LOR-90-10.76

MAJOR REHABILITATION

DESIGN-BUILD

DBT RESPONSES TO THE DEPARTMENT'S PTI EVALUATION COMMENTS

ROADWAY PLAN AND PROFILE ROLL PLOTS

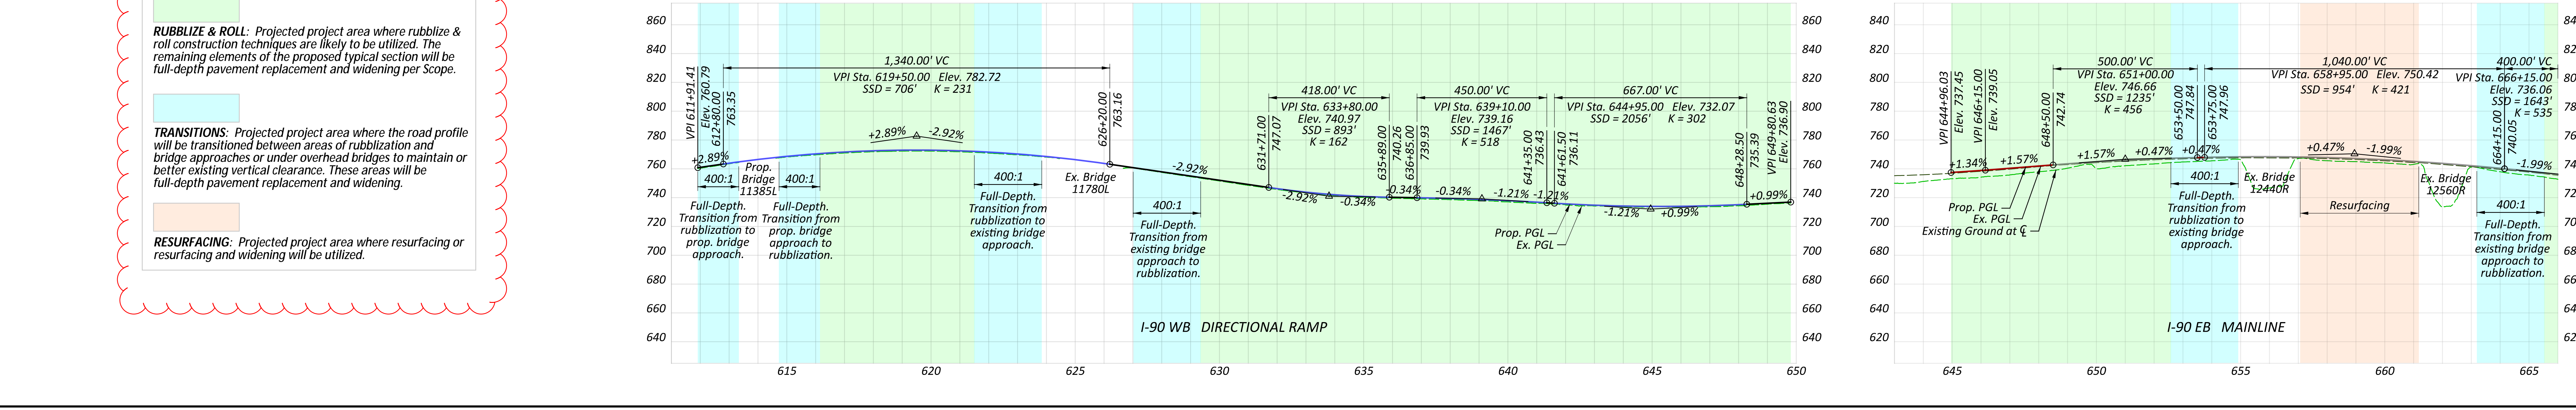
The profiles show that 400:1 vertical transition between the rubblize and roll sections and pavement replacement sections, however many of these transition areas transcend across grade breaks and vertical curve limits and some are fully contained within vertical curves. While labeled as transition areas in the submitted profiles, the transitions were not incorporated into the actual profile grade data. Vertical transition areas occurring within the limits of vertical curves are problematic as this is a condition not defined in the L&D. The effect of this transition is dependent upon a number of factors including (but not limited to) where it occurs in the curve, the roadway grades in the curve, and whether the curve is a crest or sag. For consideration, we recommend that vertical transition areas occur outside the limit of vertical curves.

The Offeror is not required to submit a revised profile with the technical proposal correcting these deficiencies; however, notes shall be added to the profile sheets acknowledging problematic depicted profiles, and the narrative revised to reflect steps to be taken to ensure the final profile shall be in conformance with ODOT design standards. Corrections may require expansion of the pavement replacement limits indicated in the plans or other steps necessary to ensure conformance with ODOT design standards.

DBT Response/Action:

Section 11 of the SOS requires the DBT to reconstruct the roadway while "generally retaining the existing constructed horizontal and vertical alignments". The original profiles have been vitiated by numerous projects and reconstruction work performed over the years. The proposed profile grade lines depicted in our drawings are derived from a compilation of historical profile data, adjusted for datum and surface variations, and incorporating PVI station rounding. These accumulated project modifications result in the composite profile shown. This approach enabled the DBT to accurately estimate the original top of concrete elevation along the corridor, a critical factor in determining quantities for Rubblize and Roll treatment (ATC No. 1).

PHASE 4A REMOVAL

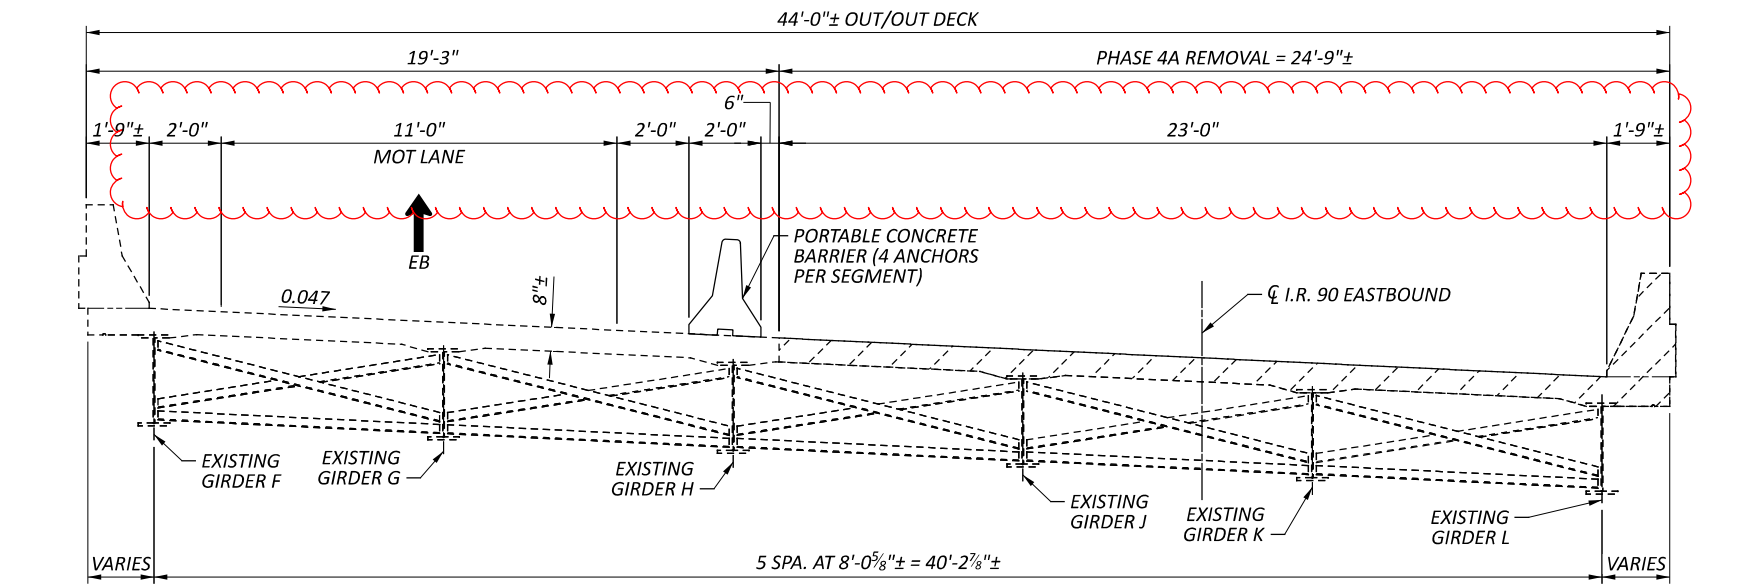
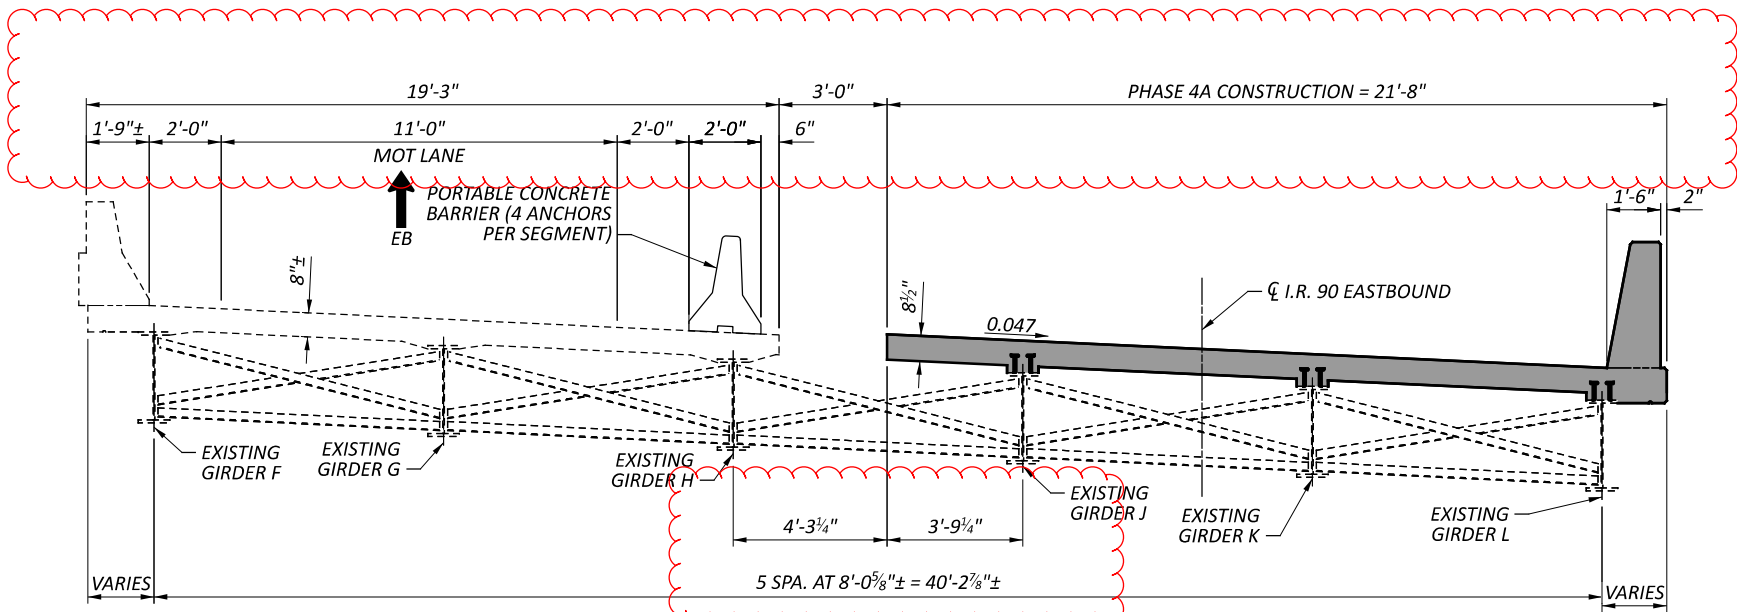
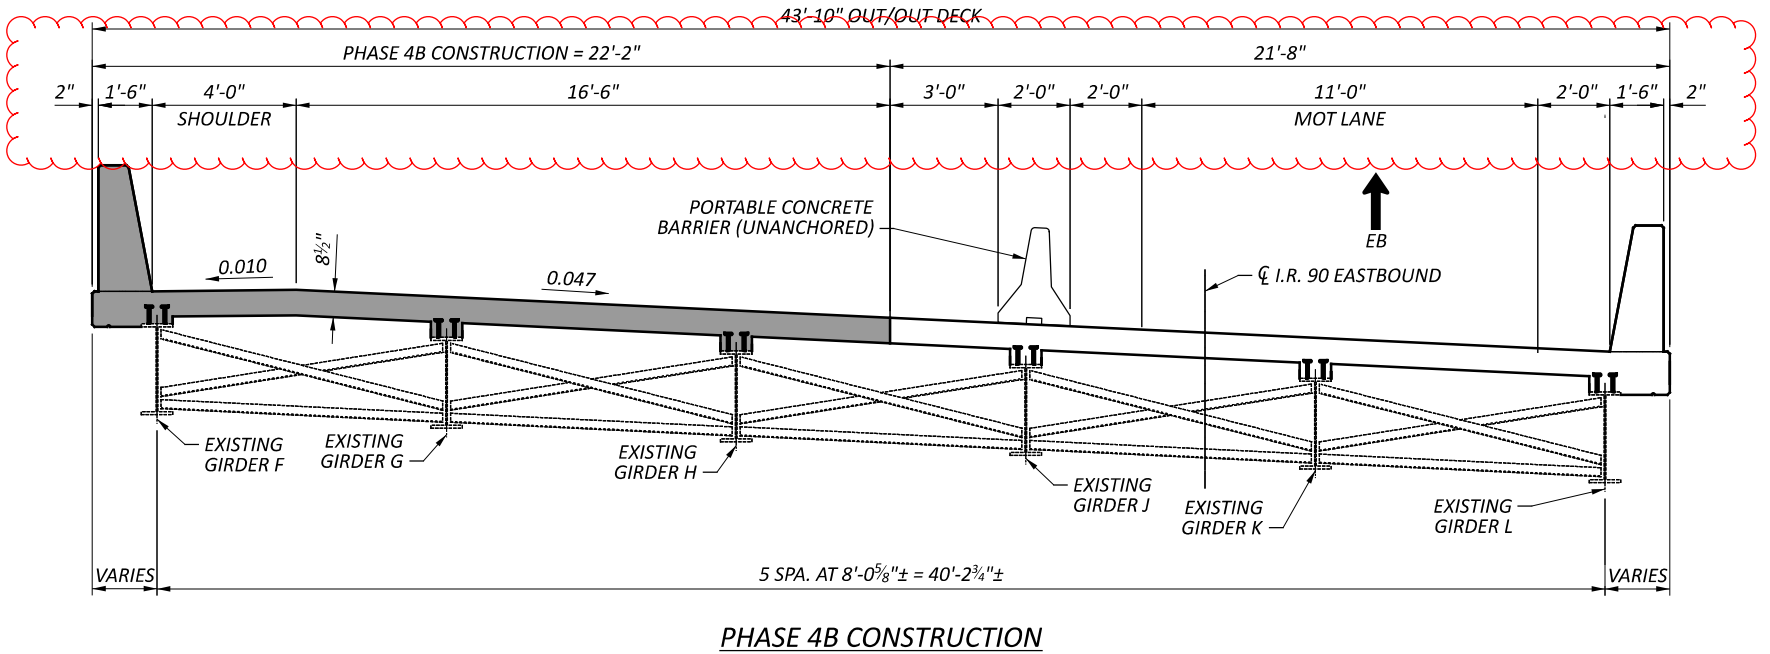
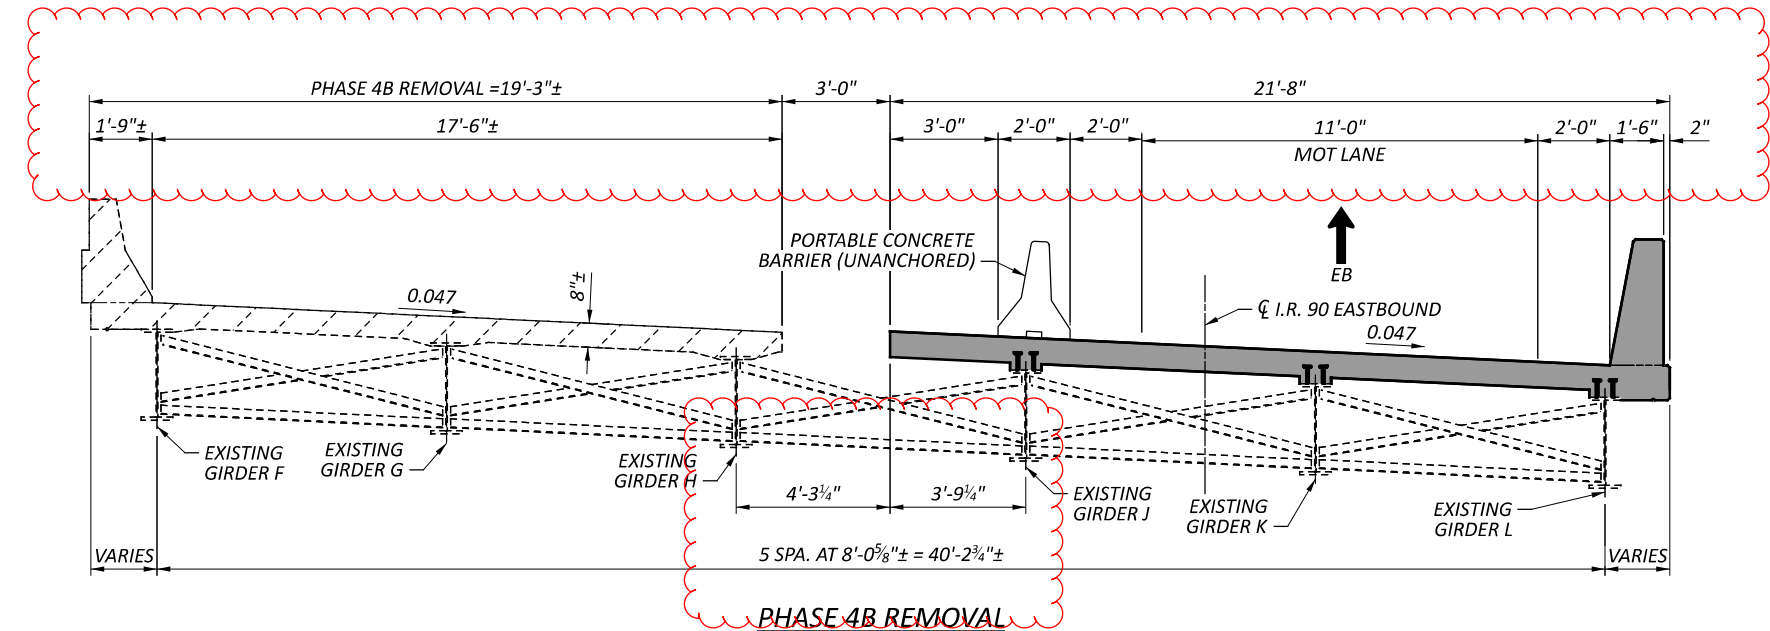
- b. Page 78: It appears the phase lines for construction could be revised to provide the preferred 2' offsets to the barrier. Revisions should be considered as approval of the reduction to 1' is the Department's discretion.

- c. Page 79: It appears the phase lines for construction could be revised to provide the preferred 2' offsets to the barrier. A detour of Murray Ridge Rd (240 day closure allowed per Section 8.2.2, Table 8-3 of scope) would reduce the required offset for non-anchored PCB to below 6'. Revisions should be considered as approval of the reduction to 1' is the Department's discretion.

The phase lines were revised to provide the preferred 2' offsets.

The phase lines were revised to provide the preferred 2' offsets.

The schedule was revised to show Murray Ridge Rd closed during the structure work for IR-90 EB over Murray Ridge Rd during Phases 4A and 4B

TRANSVERSE SECTION
BRIDGE NO. LOR-90-11570R & BRIDGE NO. LOR-90-11385L
I.R. 90 EASTBOUND/WESTBOUND OVER MURRAY RIDGE ROAD

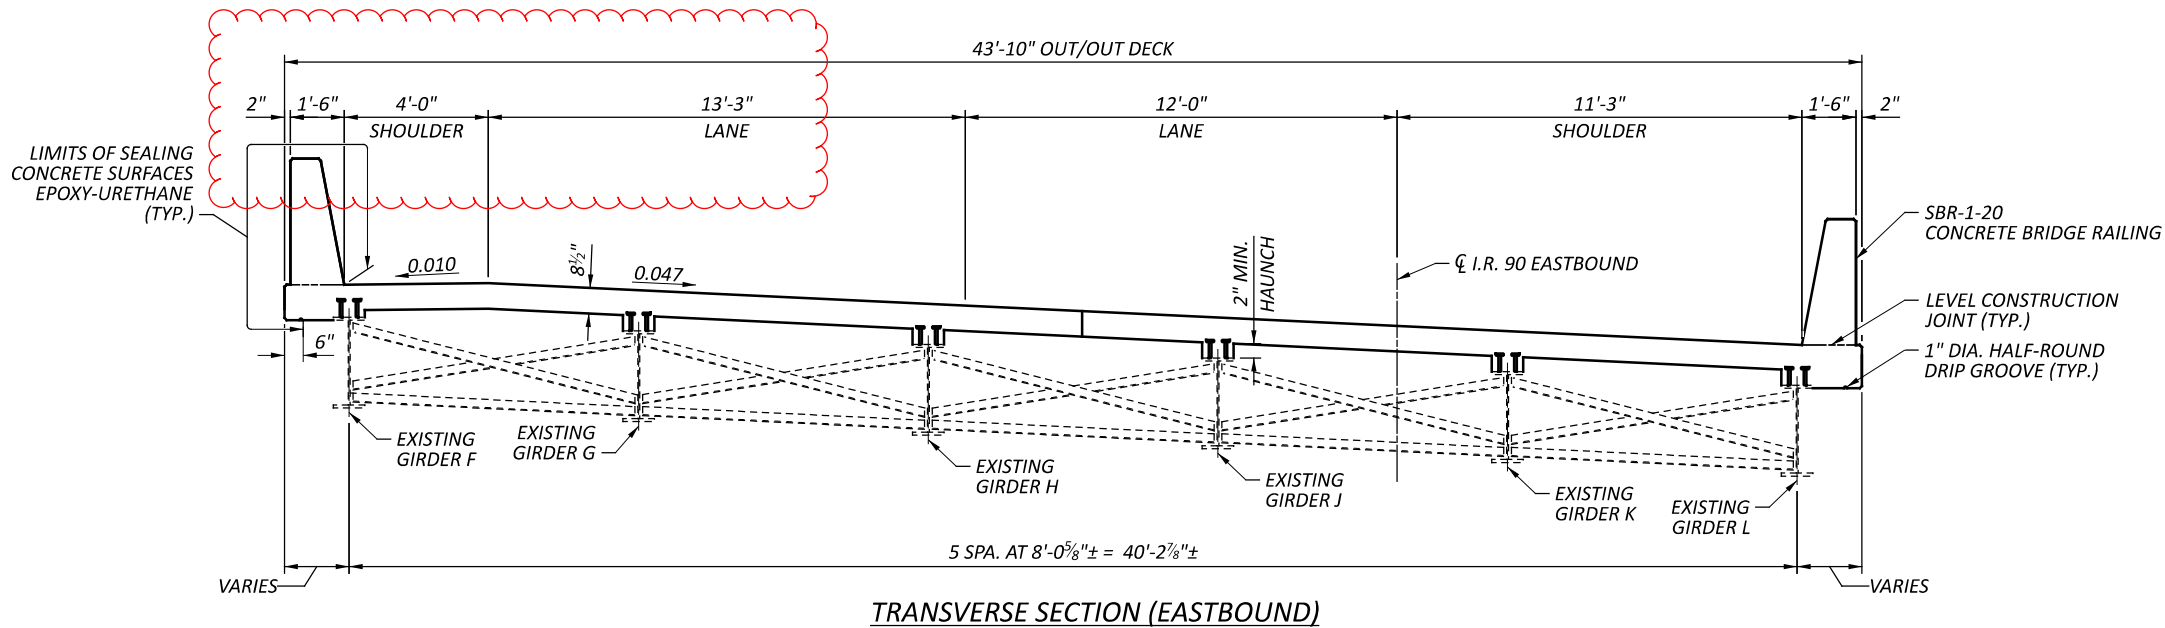
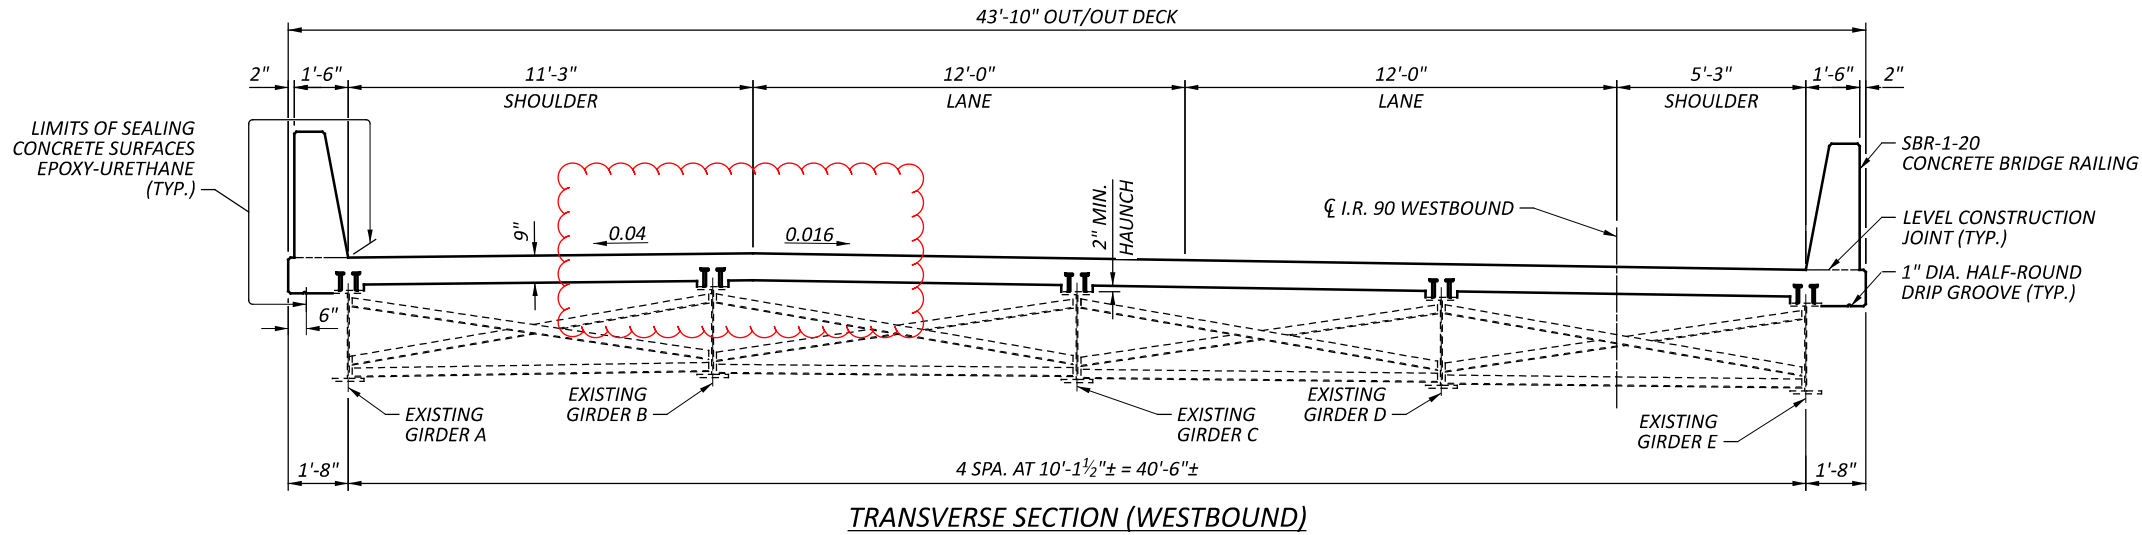
- a. Page 79: The cross slopes for the bridge high side shoulders are not in conformance with scope Section 14.2.A requirements to "Provide new reinforced concrete deck matching existing face to face of parapet width (40'-6" +/-). Deck design to conform to Bridge Design Manual (BDM) Section 309.3. Deck cross slopes (pavement and shoulders) shall match adjoining roadway section with rounding in accordance with BDM Section 309.3.6.1." This will affect and control the elevation of the bridge deck.

DBT Response/Action:

The bridge plans were revised to show the deck cross slopes matching the adjoining roadway sections, in accordance with the Scope of Services.
